SUBJECT: Forwards relief request 95-04, allowing util to take credit for limited ultrasonic exams on certain reactor vessel head welds, reactor vessel head-to-flange welds, SG nozzle-to-vessel welds & SG nozzle inside radius welds.

Subject: Duke Power Company
Oconee Nuclear Station, Units 1, 2, and 3
Docket Nos. 50-269, -270, and -287
Third Ten Year Inservice Inspection Interval
Request for Relief No. 95-04

10-YEAR INTERVAL REQUEST FOR RELIEF NO. 95-04

NO.	REVISION	DATE	DR	RV	WVD	APPD	DATE	TITLE		
								REACTOR VESSEL WELD OUTLINE		
1	ADD. REF. DWGS.		AS	ASH				DWG. NO. ISI-OCNI-001		
0	ORIGINAL		AS	ASH				REV 1

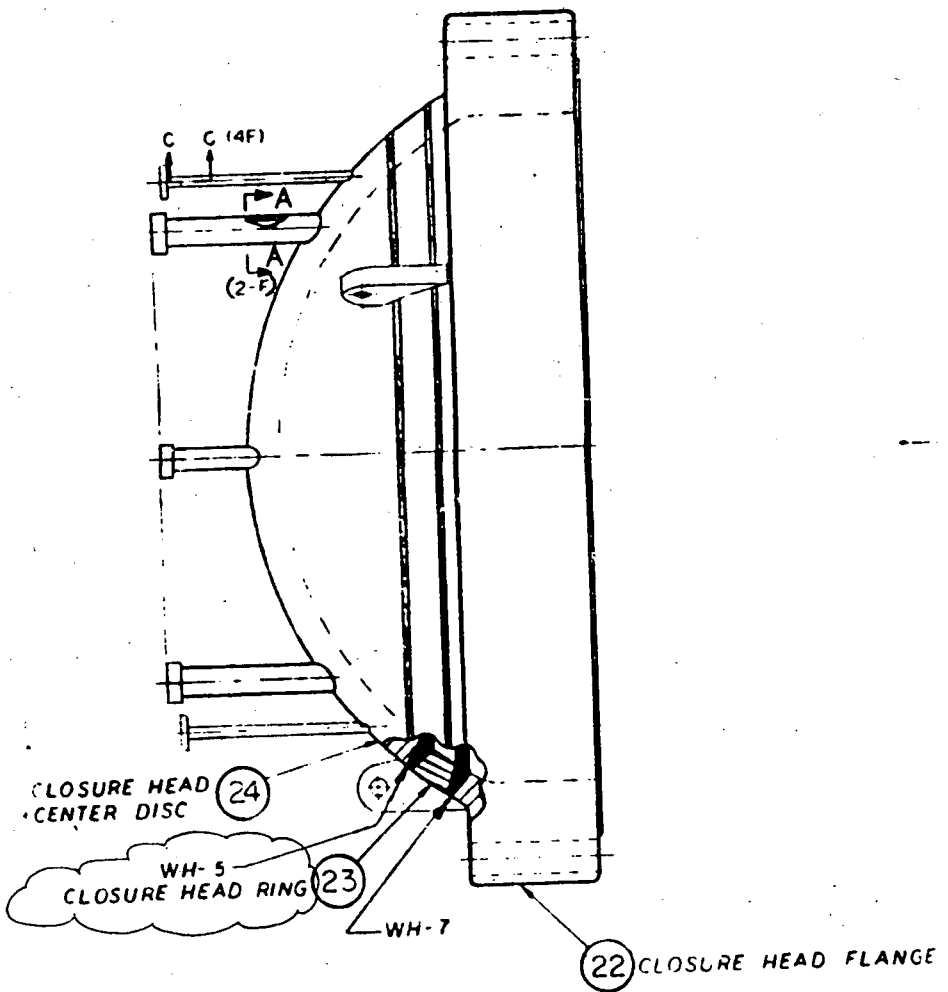
Because of geometric conditions, i.e., lifting lugs adjacent to the weld, 81.85% of the near surface volume and 79.85% of the weld and base metal volumes were covered. In order to achieve more coverage of the required volumes the lifting lugs would have to be moved away from the weld area.

Because of geometric conditions, i.e., single sided access, 63.35% of the near surface volume and 48.55% of the weld and base metal volumes were covered. In order to achieve more coverage of the required volumes, the weld must be at a greater distance from the flange.

STEAM GENERATOR

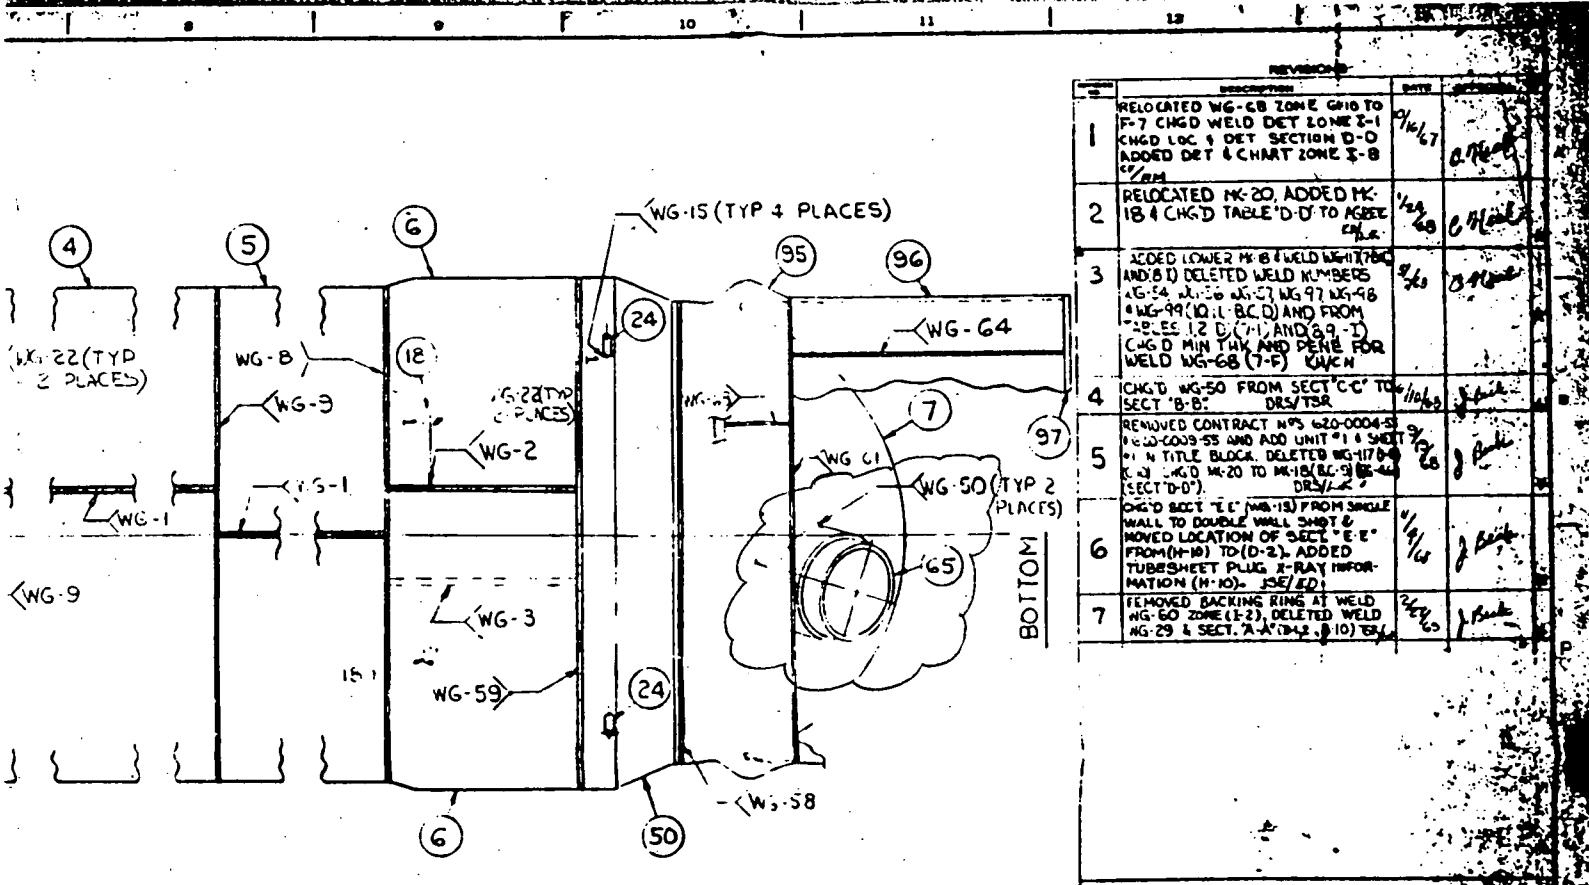
Because of geometric conditions, i.e., single sided access and support skirt location, 15.6% of the required examination volume was covered. In order to achieve more coverage the support skirt would have to be cut away from the nozzle.
